UNIVERSITY OF SOUTH CAROLINA CAPSTONE CAMPUS ROOM UPGRADES

PROJECT NO: 11103

ADDENDUM 02

March 16, 2012

1
1-7
CEILING DETAIL
SCALE: 1 1/2" = 1'-0"

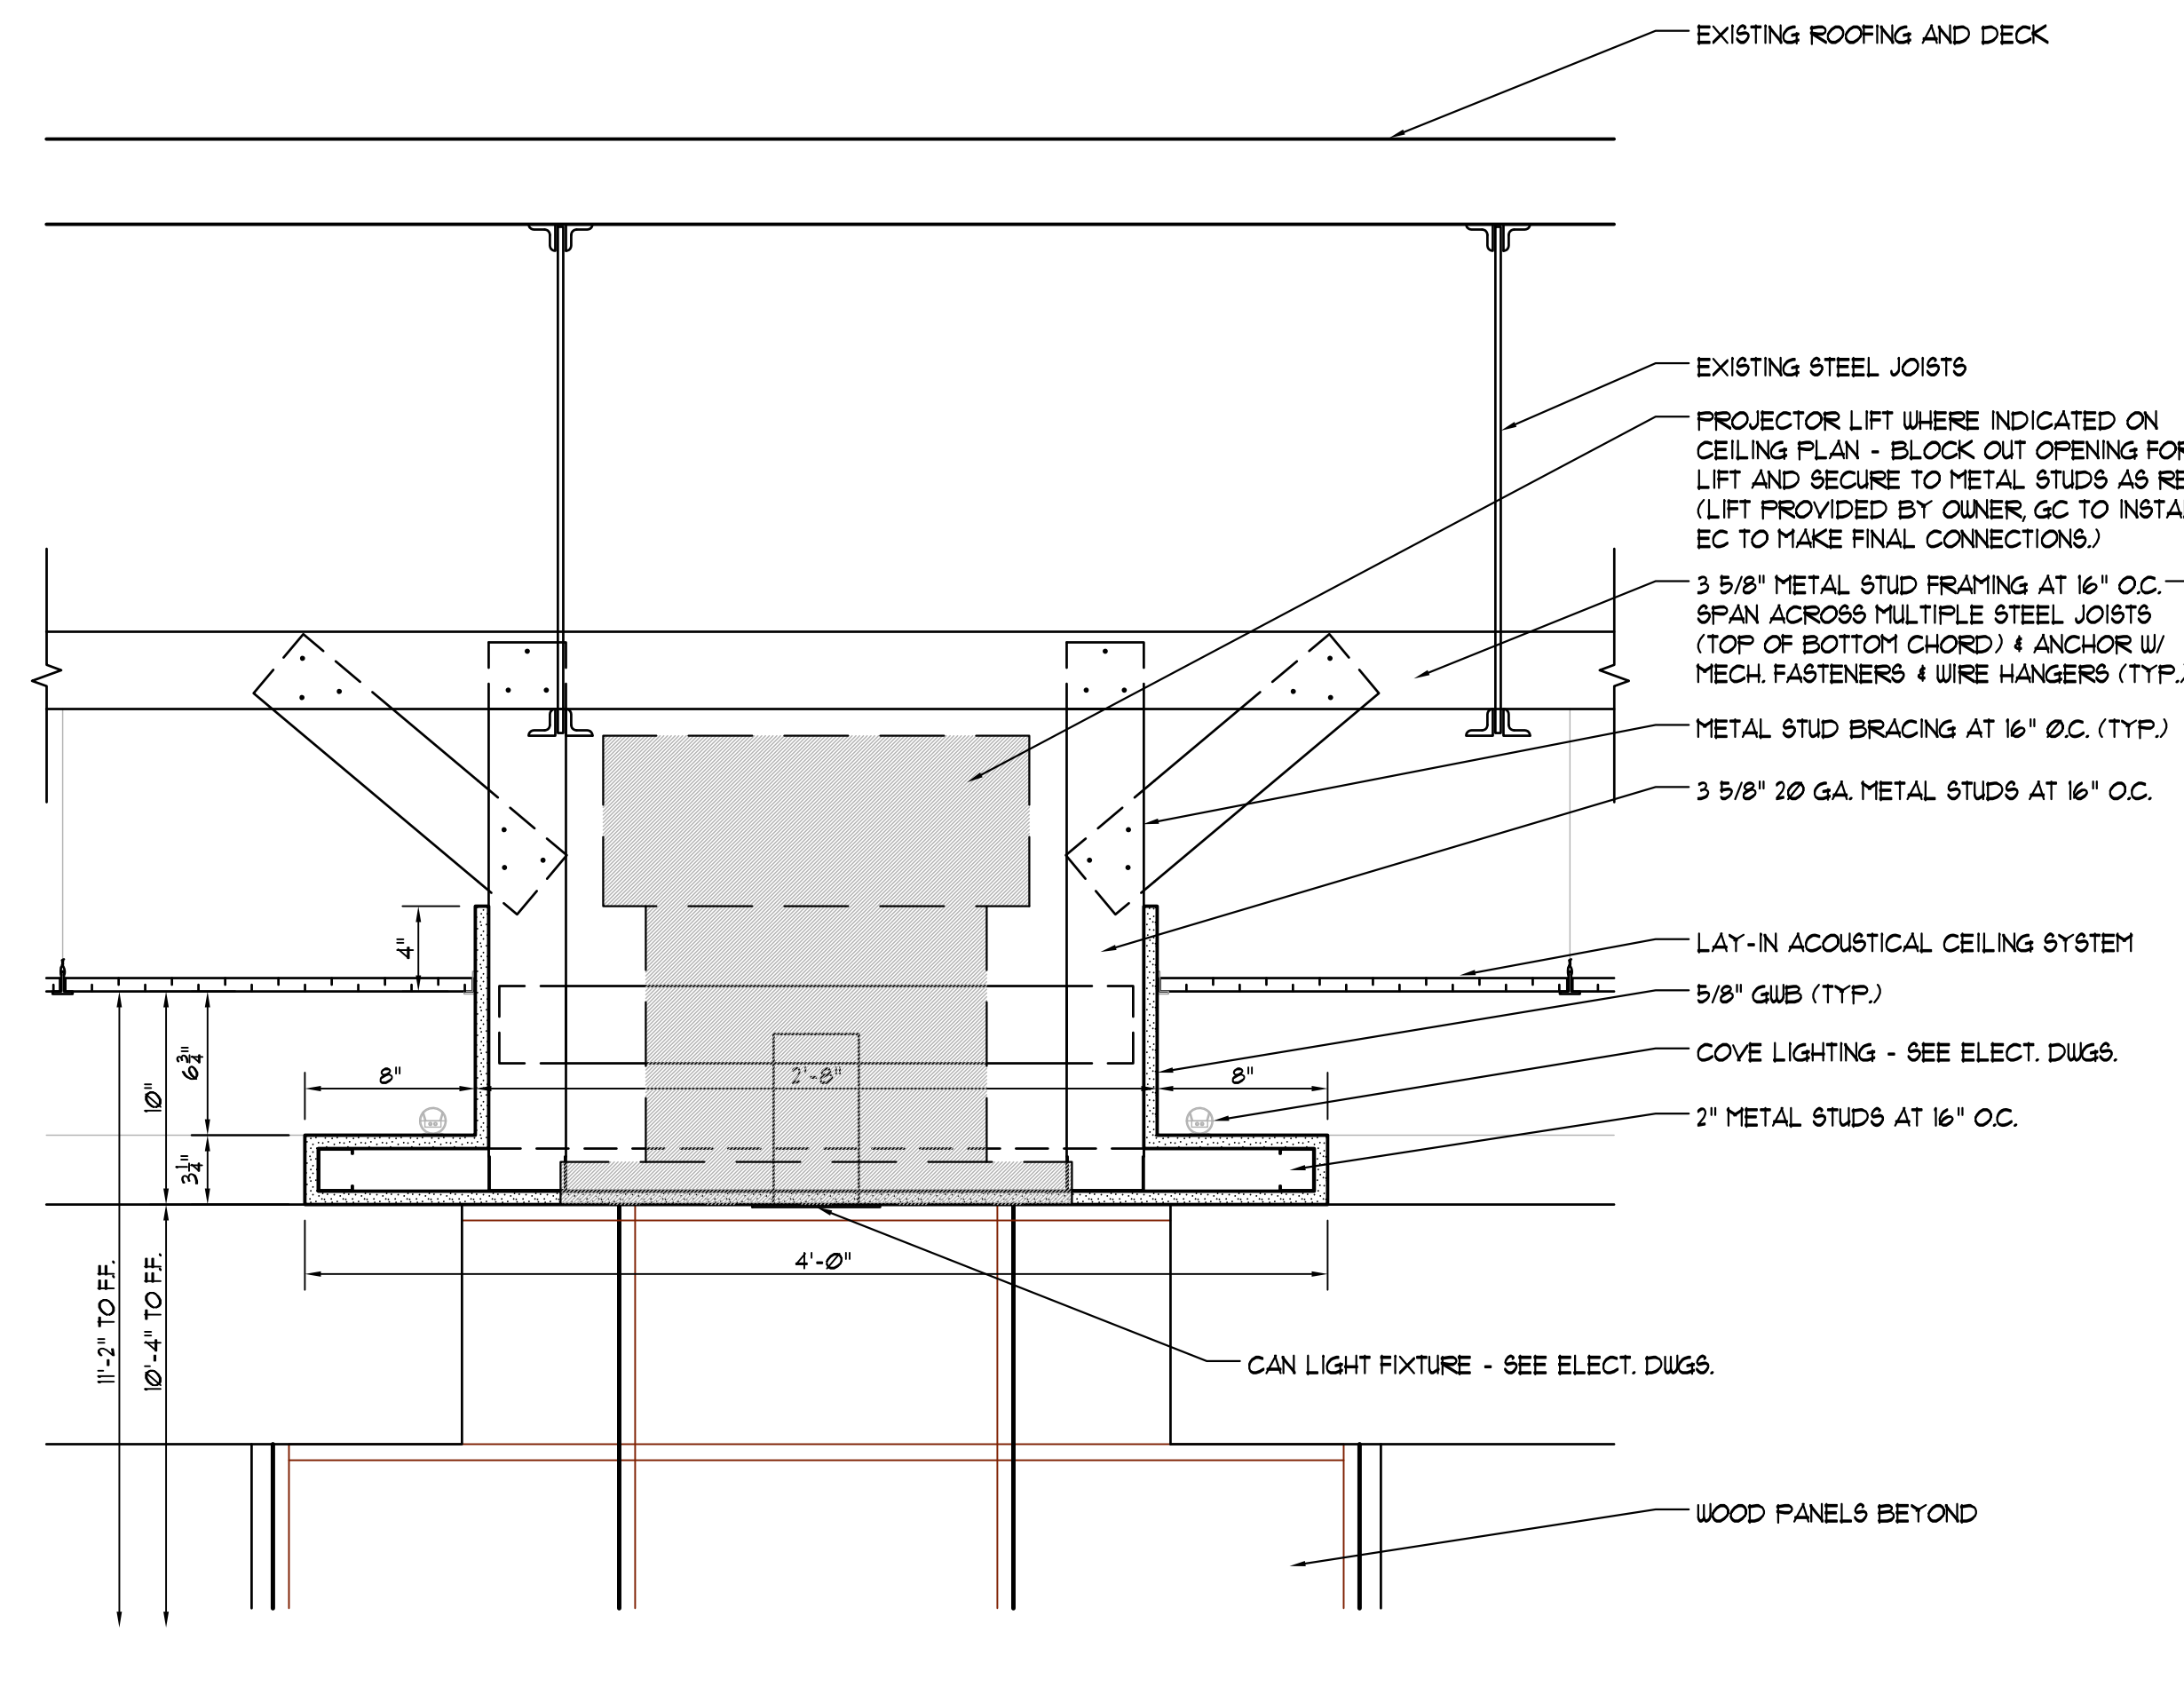
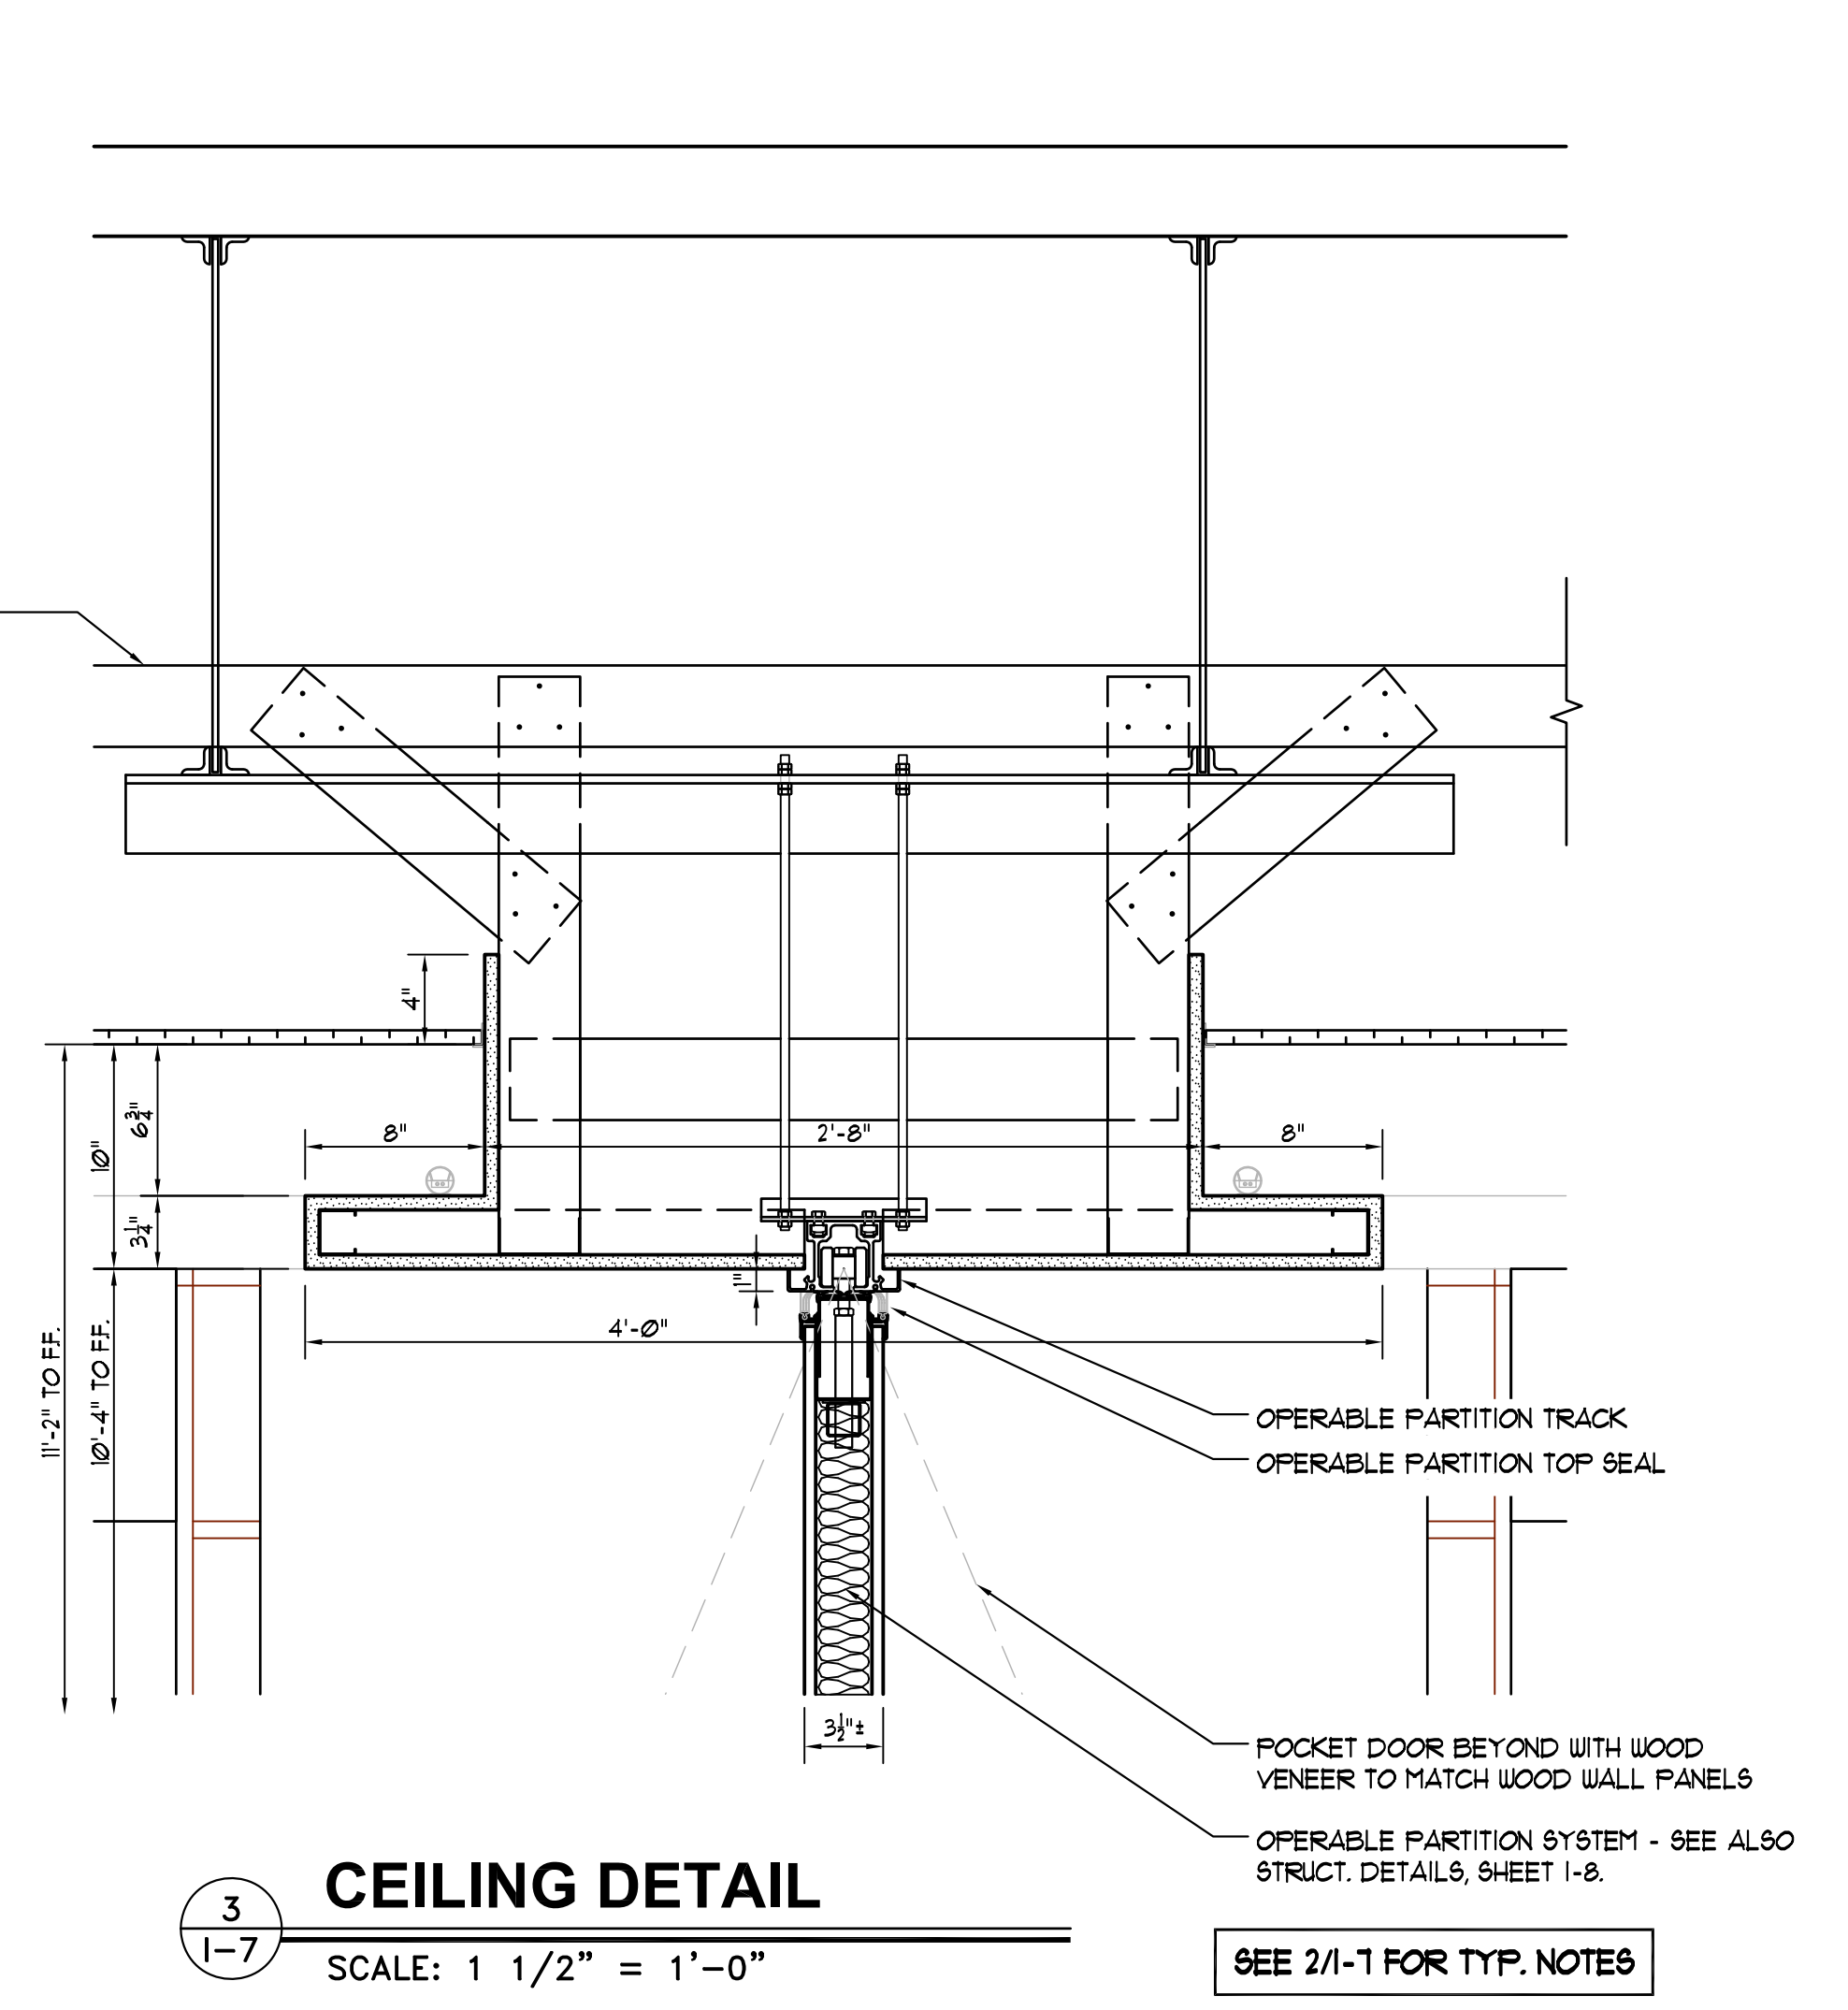
1. **Drawing I-7 CEILING DETAILS:** OMIT Drawing I-7 and **REPLACE** it with NEW DRAWING I-7.
2. **Drawing I-5 DOOR & FINISH SCHEDULES / COLOR SCHEDULE / DOOR & WINDOW TYPES & DETAILS / PANEL DETAILS:** CHANGE Wood Veneer Panel Reveal Details as shown.
